# HISTORIC AND DESIGN REVIEW COMMISSION

June 01, 2022

**HDRC CASE NO:** 2022-293  
**ADDRESS:** 1024 N CHERRY  
**LEGAL DESCRIPTION:** NCB 512 BLK 25 LOT W 99.55 FT OF 3  
**ZONING:** R-4, H  
**CITY COUNCIL DIST.:** 2  
**DISTRICT:** Dignowity Hill Historic District  
**APPLICANT:** Joseph Munoz  
**OWNER:** Joseph Munoz  
**TYPE OF WORK:** Construction of a rear addition, exterior modifications, fenestration modifications, porch modifications, roof form modifications, window replacement and siding modifications  
**APPLICATION RECEIVED:** May 17, 2022  
**60-DAY REVIEW:** Not applicable due to City Council Emergency Orders  
**CASE MANAGER:** Edward Hall

SCALE: 1/4" = 1'

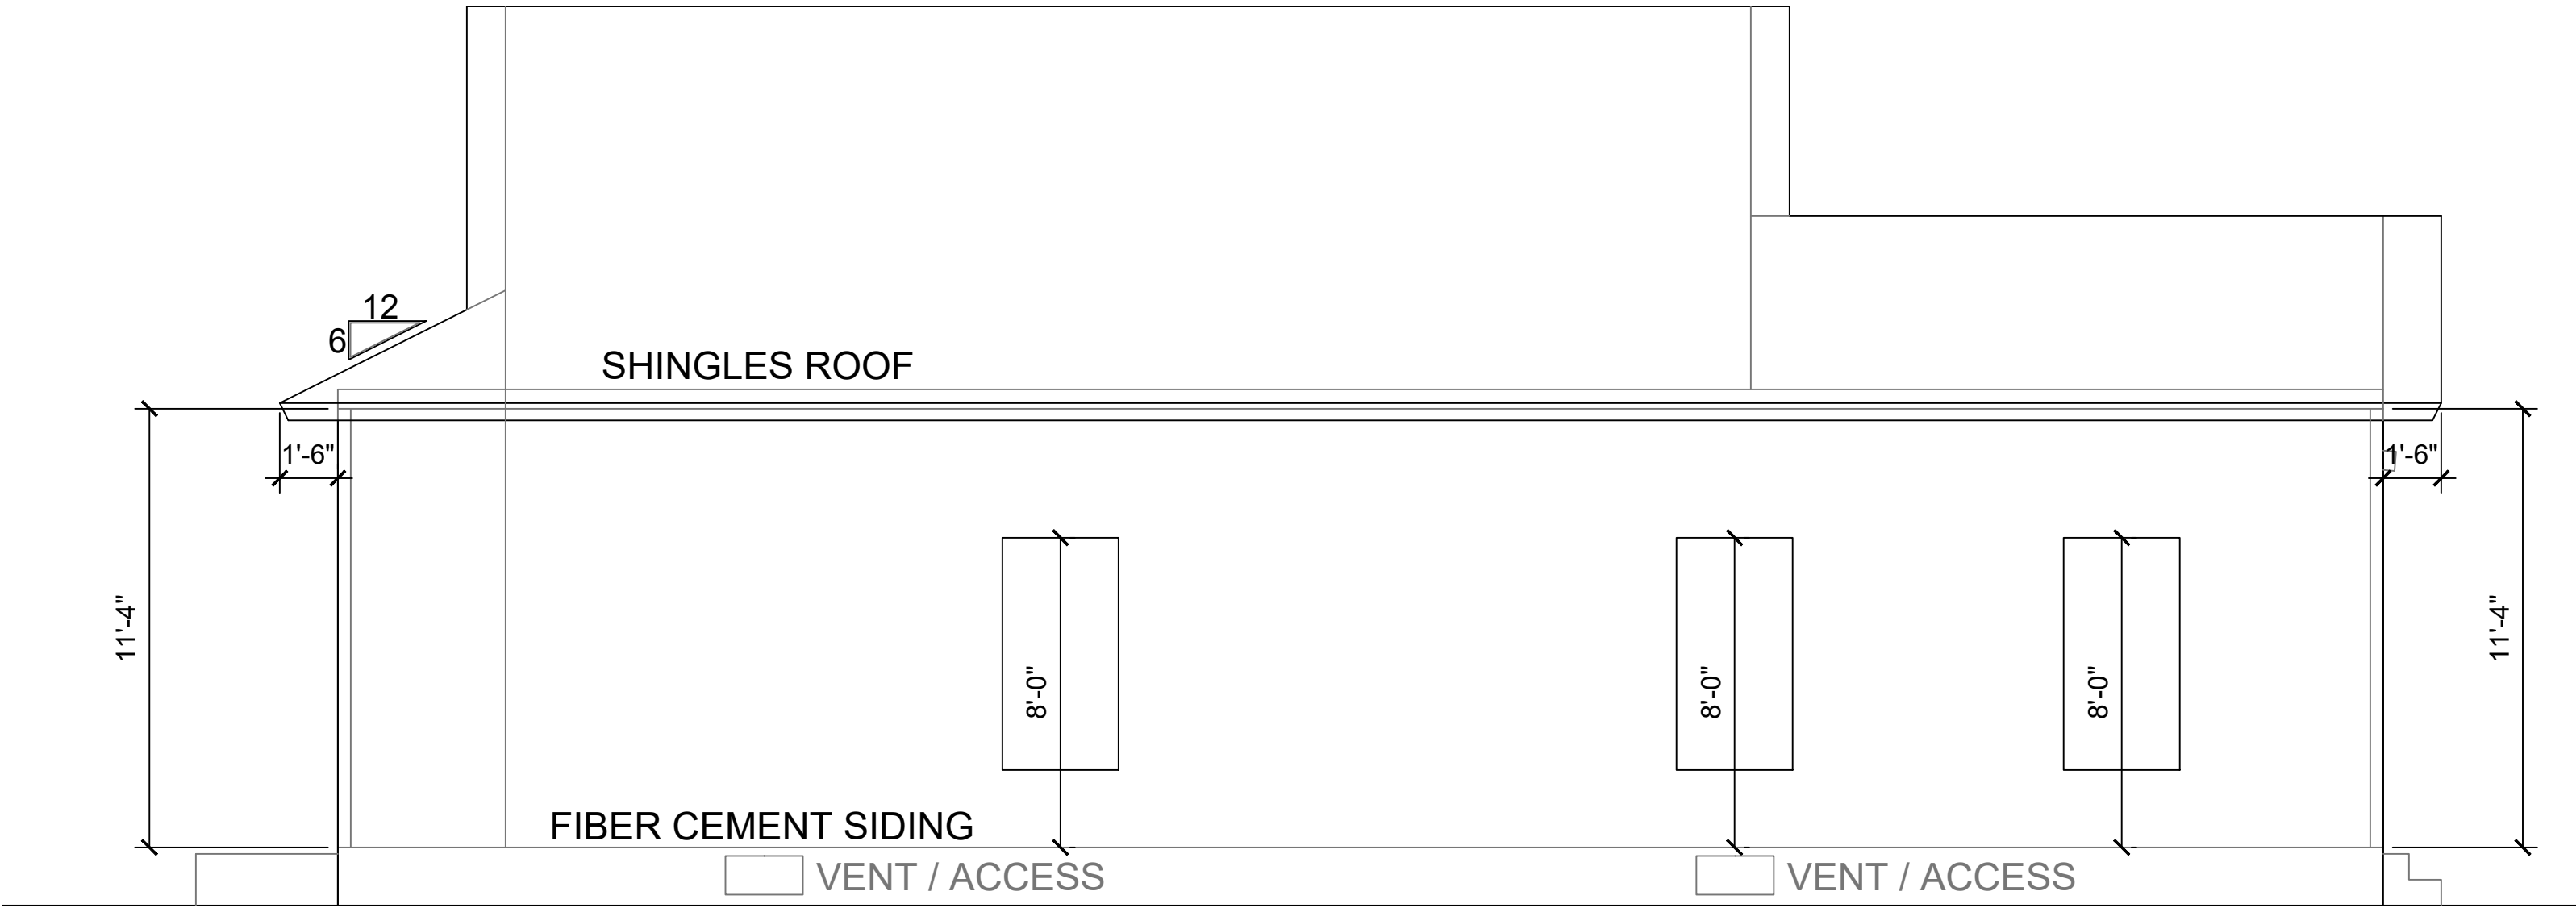
- d. FENESTRATION MODIFICATIONS – The applicant has proposed fenestration modifications that include modifying the existing, historic fenestration pattern of the historic structure by modifying existing door and window openings on the west, north and south facades. Within this request, the applicant has proposed to eliminate the side facing front door within the porch, relocate the street facing front door and modify the head and sill heights, widths, opening locations, and profiles of various windows on each façade. The Guidelines for Exterior Maintenance and Alterations 6.A. note that existing window and door openings should be preserved and that new openings should not be created on the primary façade or where visible from the public right of way. Additionally, the Guidelines note that original opening should not be increased or reduced in size to fit stock window sizes. Staff finds the proposed modifications to be inappropriate and inconsistent with the Guidelines. Staff finds the original sizes, locations and profiles of all windows and doors should be restored.

- f. ROOF FORM MODIFICATIONS – The applicant has proposed to modify the structure's roof form and various architectural elements that are associated with the roof that include eave details, the installation of gable returns, modifications to existing attic vents. The Guidelines for Exterior Maintenance 3.B.ii. notes that the original shape, line, pitch, and overhangs of original roof forms should be preserved. Additionally, eaves and other decorative elements should be preserved. The proposed modifications are inappropriate and consistent with the Guidelines. Staff finds that the original roof forms and attic vents should be reinstalled.

- g. PORCH FORM MODIFICATIONS – The applicant has proposed to make porch modifications including the construction of a new porch roof, a change in porch deck height, and the installation of new porch columns. The existing porch featured modified elements, including modified columns, railings and beams. Staff finds that the existing porch profile should be reconstructed, based on photographic evidence. Columns should feature six inches square with capital and base trim. Fascia and soffit details should be consistent with historic, Folk Victorian examples found within the district. The frieze board should be reinstalled at the previous profile.

- h. SIDING/TRIM MODIFICATIONS – The applicant has proposed to remove the existing, non-original siding and install composite siding with a faux wood grain finish with an exposure of approximately 8 inches as well as install composite trim with faux wood grain. The historic house previously featured a combination of aluminum siding and T-111 siding. The Guidelines for Exterior Maintenance and Alterations 1.B. notes that façade materials that are original should be preserved. When original siding is beyond repair, new siding should be in-kind with the original. Staff finds the composite siding and trim to be inappropriate and inconsistent with the Guidelines. Staff finds the historic structure should feature siding and trim with a profile that is consistent with historic Folk Victorian examples within the district.

greater than that of the historic structure, resulting in a front facing gable that rises above the historic structure's ridge line. Staff finds the proposed roof form to be inappropriate and inconsistent with the Guidelines.

- ii. That the frieze board be reinstalled at the previous profile.
2. Staff does not recommend approval of item #2, modifications to the original fenestration pattern including both windows and doors, based on finding d. Staff recommends the original sizes, locations and profiles of all windows and doors be restored.

4. Staff does not recommend approval of item #4, modifications to the historic structure's roof form based on finding f. Staff recommends that the original roof forms and attic vents be reinstalled.

5. Staff does not recommend approval of item #5, modifications to the historic structure's porch form based on finding g. Staff recommends the existing porch profile be reconstructed, based on photographic evidence. Columns should feature six inches square with capital and base trim. Fascia and soffit details should be consistent with historic, Folk Victorian examples found within the district.

6. Staff does not recommend approval of item #6, siding replacement and trim replacement with composite materials, based on finding h. Staff recommends that the historic structure feature siding and trim with a profile that is consistent with historic Folk Victorian examples within the district. Siding and trim should be wood.

ROOF PLAN  
SCALE: 1/4" = 1'

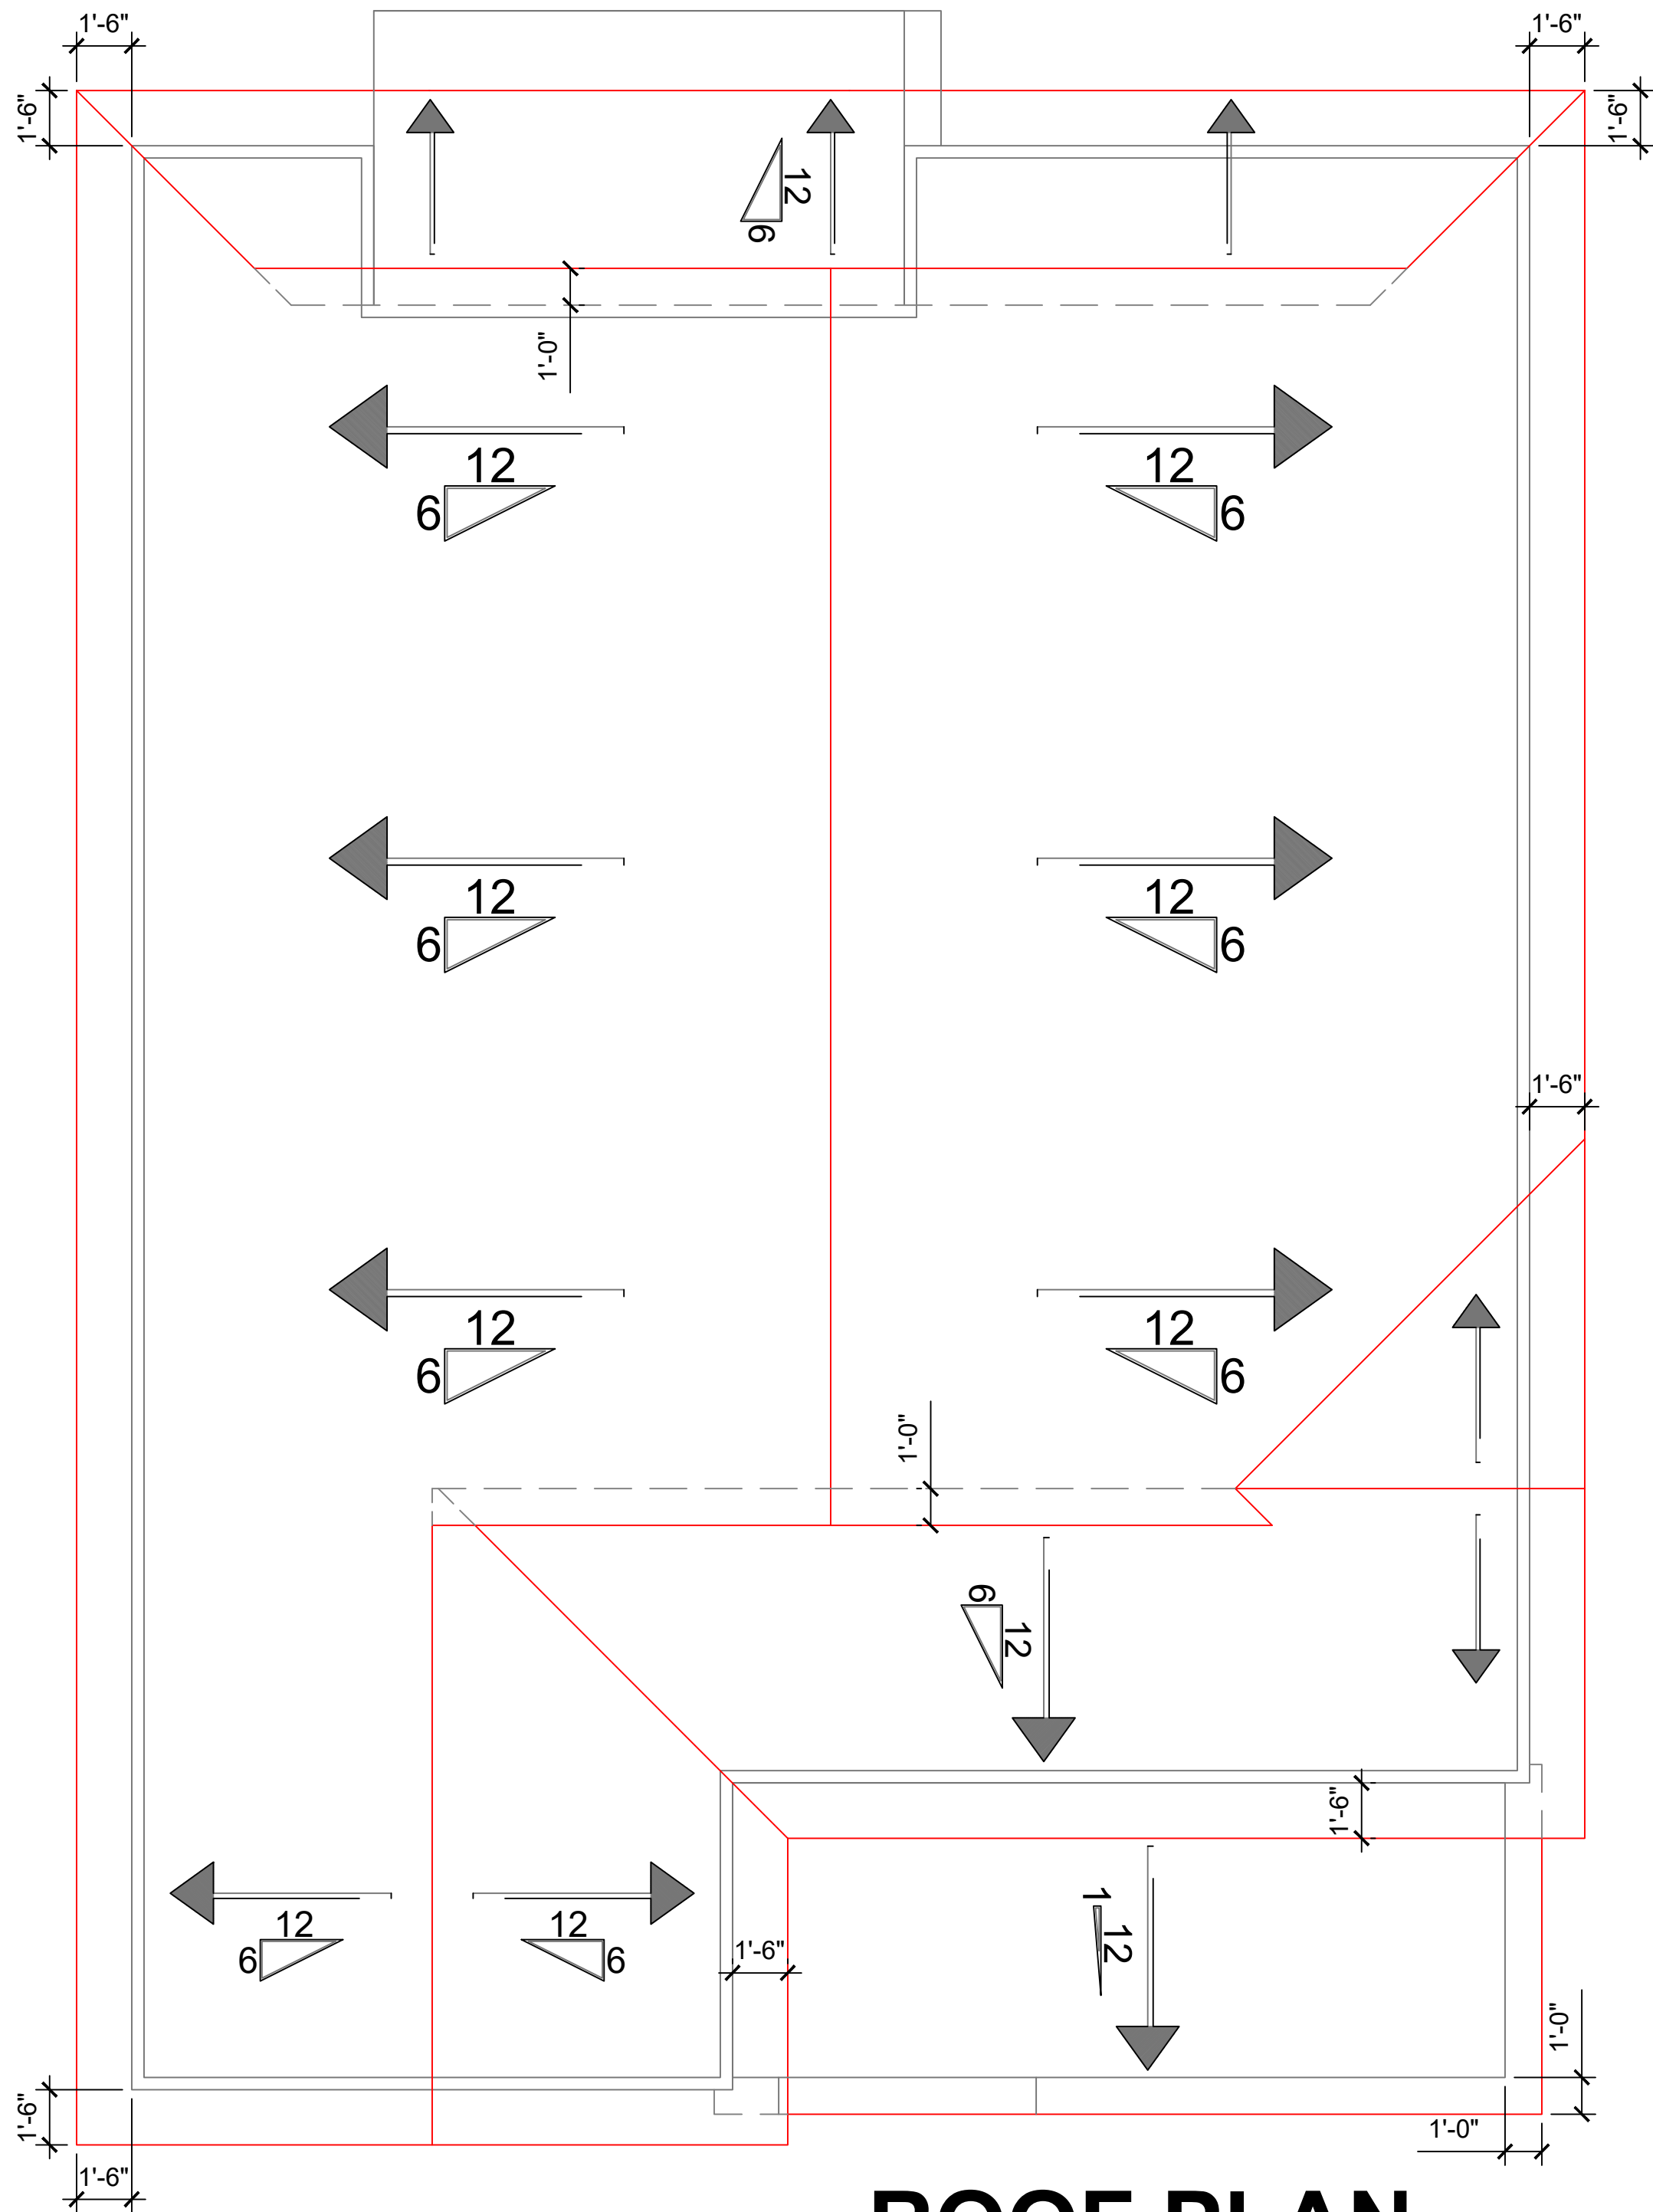
- l. ROOF FORM – The applicant has proposed for the rear addition to feature a roof that features a front facing gable and a rear gable/hip combination. The proposed roof form features a profile and overall height that are

- iv. That the proposed addition feature a massing that is subordinate to that of the historic structures, including a reduced roof form that does not impact the primary ridge line of the historic structure. The rear addition's roof should not impact the primary, front façade of the historic structure.
